## IDAP REPORT – SECTION 4.55(1A) MODIFICATION

<b>Property:</b>	8 Marion Street STRATHFIELD Lot: 81 DP: 12405 DA2020.254.2
<b>Proposal:</b>	S4.55(1A) Modification Application seeking to amend the finish material of the rear extension from face brick to render and colour of boundary fences.
<b>Applicant:</b>	DM Investments Aust Pty Ltd
<b>Owner:</b>	Joseph Abdal and Layla Yarak
<b>Date of lodgement:</b>	12 July 2022
<b>Notification period:</b>	18 July – 1 August 2022
<b>Submissions received:</b>	0
<b>Assessment officer:</b>	W van Wyk
<b>Estimated cost of works:</b>	\$285,000.00
<b>Zoning:</b>	R2-Low Density Residential - SLEP 2012
<b>Heritage:</b>	Yes – Located within the C12 Marion Street Conservation Area, Inter-war bungalow style group
<b>Flood affected:</b>	Yes
<b>RECOMMENDATION OF OFFICER:</b>	REFUSAL

**Figure 2:** Proposed Western (Street) Elevation (modification in pink)

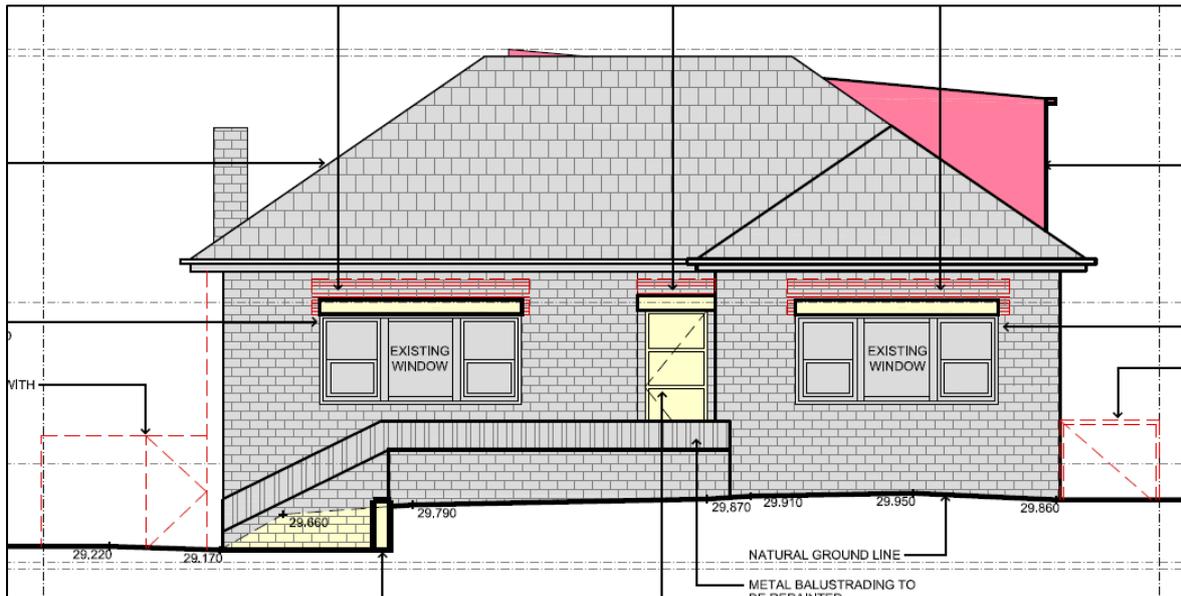
The rendered elevations in a light hue will be inconsistent with the surrounding HCA, which comprises dark coloured brick. The rendered elements will be highly visible from the street and will dominate the existing contributory building. It is noted that the works will also be visible from Fraser Street at the rear. To be clear, both the colour and the material are of concern. Simply painting the rendered elevation a darker colour will remain inconsistent with the adjoining brick extension, and result in a loss of texture and visual interest.

As discussed, the bulk of the approved extension is not changing and is considered acceptable. However, the change in materials and colours is inconsistent with the characteristic dark coloured brick and is not acceptable.
